PG&E Letter DCL-22-018
PG&E Letter DIL-22-007

Diablo Canyon Units 1 and 2
Docket No. 50-275, OL-DPR-80
Docket No. 50-323, OL-DPR-82
Docket No. 72-26, Materials License No. SNM-2511
Diablo Canyon Independent Spent Fuel Storage Installation
Responses to NRC Requests for Additional Information on "License Amendment
Request 21-04, Proposed Changes to the Diablo Canyon Power Plant Emergency
Plan for Post-Shutdown and Permanently Defueled Condition"

Responses to NRC Request for additional information – Diablo Canyon proposed changes to emergency plan for post-shutdown and permanently defueled condition (EPID: L-2021-LLA-0190)

5.22 FIGURE 5-2, TSC ORGANIZATION

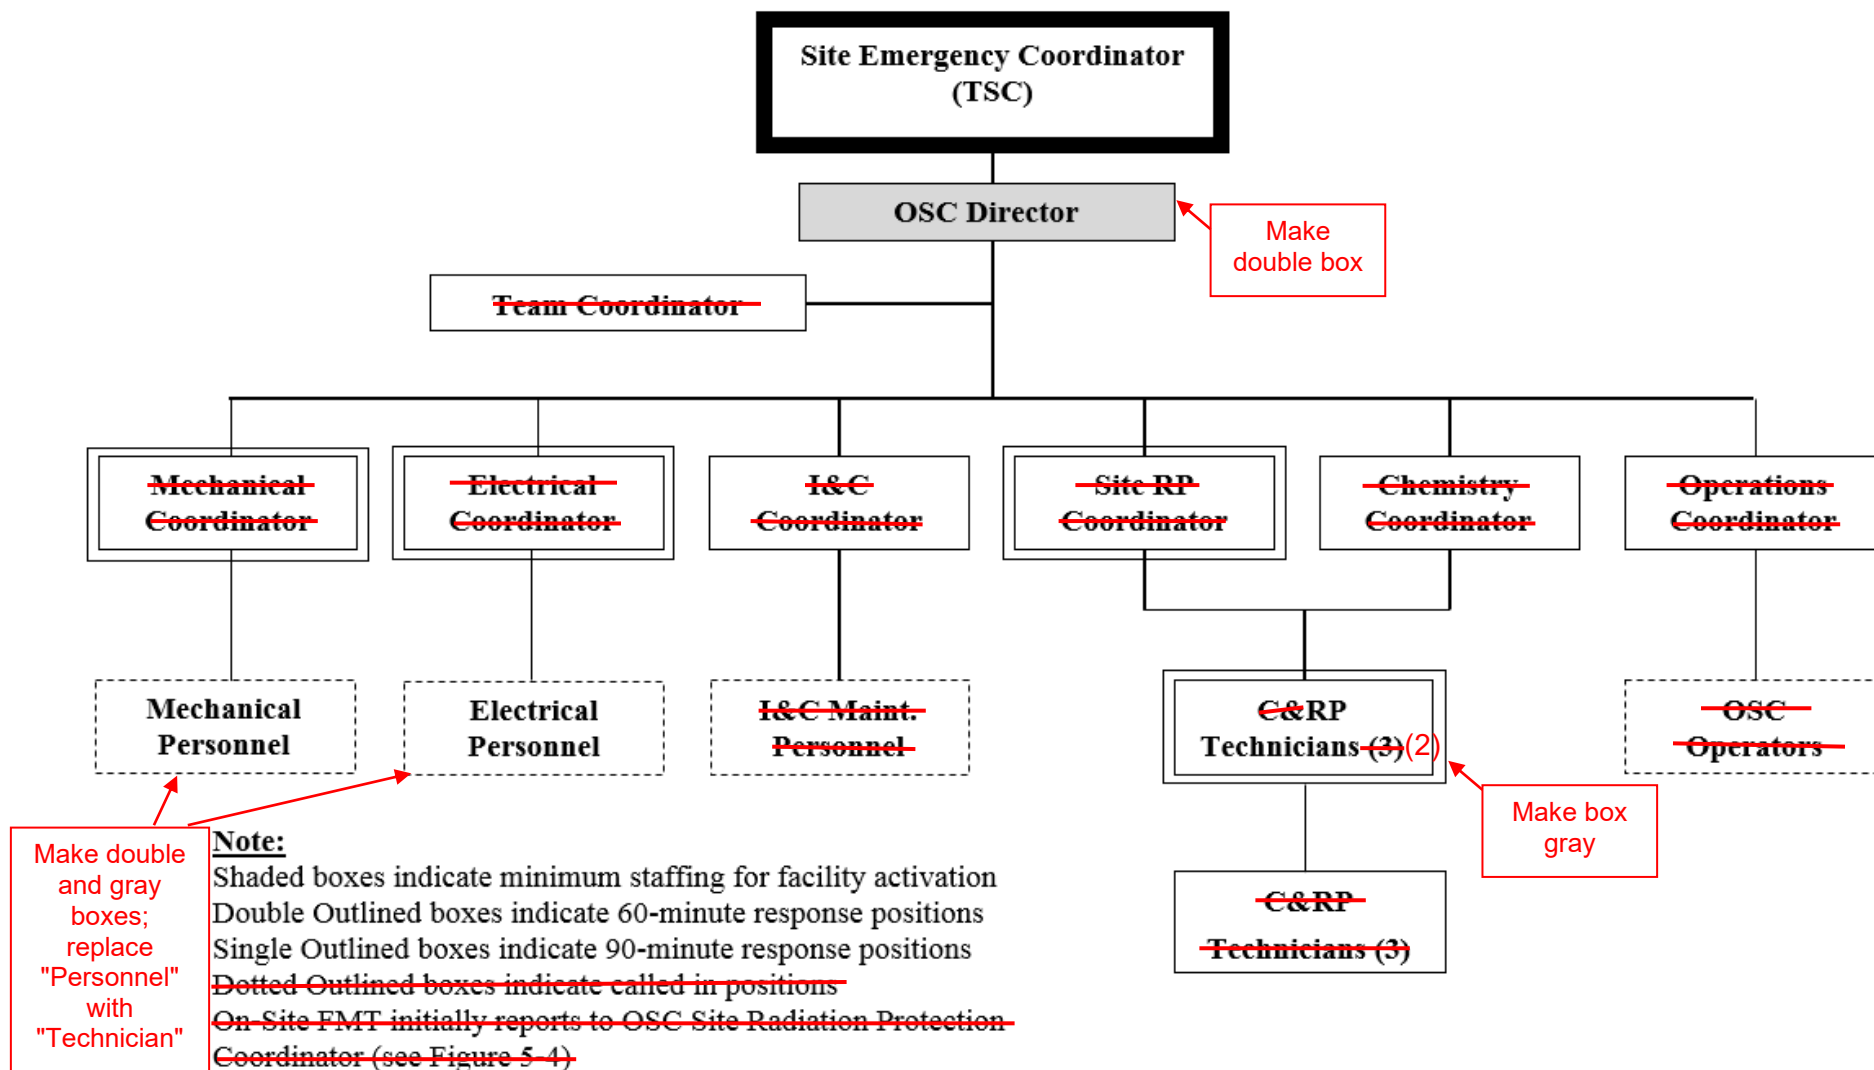
RAI-1

Issue:

Enclosure 1, "Evaluation of the Proposed Changes," Section 5.2.5.a, "Major Tasks: Technical Support/Accident Analysis," of the LAR states, in part:

The PG&E analysis of the proposed post-shutdown On-Shift and Augmented ERO Staffing Assessment concluded that in a permanently defueled condition, the TSC [Technical Support Center] Engineering Advisor will be qualified to provide engineering support in response to a Fuel Handling Accident (FHA) in the fuel handling building or an event resulting in damage to the Spent Fuel Pool (SFP) integrity or loss of SFP cooling or inventory. As a result of this analysis, PG&E proposed that the TSC Engineering Advisor would assume the functions of engineering support and therefore, has proposed to eliminate both the currently approved Mechanical and Electrical Engineering 60-minute response positions and replacing those emergency positions with a proposed 90-minute response position of a TSC Engineering Advisor. [emphasis added]

The current ERO staffing for the DCPD was approved by the NRC in a letter dated August 21, 2019 (ADAMS Accession No. ML19196A309) and is based on the guidance provided in a letter to the Nuclear Energy Institute dated June 12, 2018 (ADAMS Accession No. ML18022A352), that provided alternative guidance (referred to as the Revised Table B-1) to nuclear power plant licensees for Evaluation Criterion II.B in NUREG-0654, for minimum ERO on-shift and augmentation staffing.

However, the guidance in Revised Table B-1 identifies engineering support augmenting the on-shift staff within 60 minutes of the declaration of an Alert or higher emergency classification level (ECL). This is consistent with the current DCPD E-Plan staffing, as well as the current precedence of other decommissioning sites implementing these types of proposed changes to the ERO staffing.

As proposed, the minimum engineering staffing will not allow the facilities to perform the intended functions within 60 minutes (e.g., Plant System Engineering is provided by the TSC Engineering Advisor with a 90-minute response).

Describe how the augmented engineering staffing will continue to be aligned with the current DCPD E-Plan to ensure the continued effective and timely implementation of the major task of Technical Support/Accident Analysis within 60 minutes of the declaration of an Alert or higher ECL.

To ensure the continued effective and timely implementation of the major task of Technical Support/Accident Analysis, the proposed Diablo Canyon Power Plant (DCPP) Emergency Plan (E-Plan) is revised to designate the Technical Support Center (TSC) Engineering Advisor as a minimum staff 60-minute responder (i.e., within 60 minutes of the declaration of an Alert or higher emergency classification level [ECL]).

Qualifications for the TSC Engineering Advisor position selection criteria will align with the current position requirements. As discussed in Enclosure 1, Section 5.2.5a of the license amendment request, the Attachment 4 Task Analysis concluded that all of the TSC Engineers' responsibilities and tasks can be eliminated. As such, no new tasks are being added to the TSC Engineering Advisor position and the Engineering function will continue to be maintained by the TSC Engineering Advisor without competing priorities. Revised DCPP E-Plan, Sections 5.19 and 5.22, markup and clean pages are provided in the Attachments of this Enclosure to reflect this change.

5.23 FIGURE 5-3, OSC ORGANIZATION

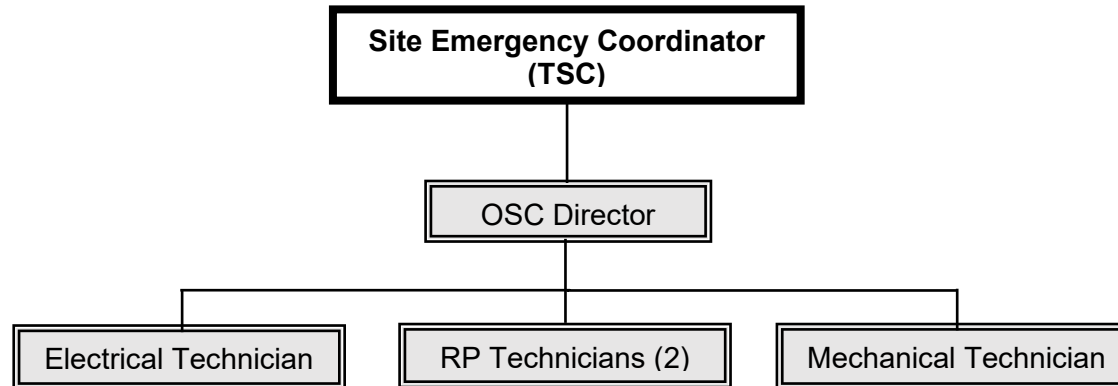
As proposed, the minimum maintenance staffing will not allow the facilities to perform the intended functions within 60 minutes (e.g., maintenance support is provided by the OSC Director with a 90-minute response with Mechanical Maintenance and Electrical/Instrumentation and Controls (I&C) Maintenance positions called-in as needed to support repair and corrective actions).

Describe how the augmented maintenance staffing will continue to be aligned with the current DCPPE-Plan to ensure the continued effective and timely implementation of the major task of Repair and Corrective Actions within 60 minutes of the declaration of an Alert or higher ECL.

To ensure the continued effective and timely implementation of the major task of Repair and Corrective Actions, the proposed DCPPE-Plan is revised to maintain the Operations Support Center (OSC) Director as a minimum staff 60-minute responder (i.e., within 60 minutes of the declaration of an Alert or higher ECL). In addition, one qualified Mechanical Maintenance technician and one qualified Electrical Maintenance technician will be minimum staff 60-minute OSC responders. Revised DCPPE-Plan, Sections 5.7.3, 5.19, 5.20, and 5.23, markup and clean pages are provided in the Attachments of this Enclosure to reflect these changes.

Shaded boxes indicate minimum staffing for facility activation
Double boxes indicate 60-minute response positions
Other OSC positions are 90-minute responders
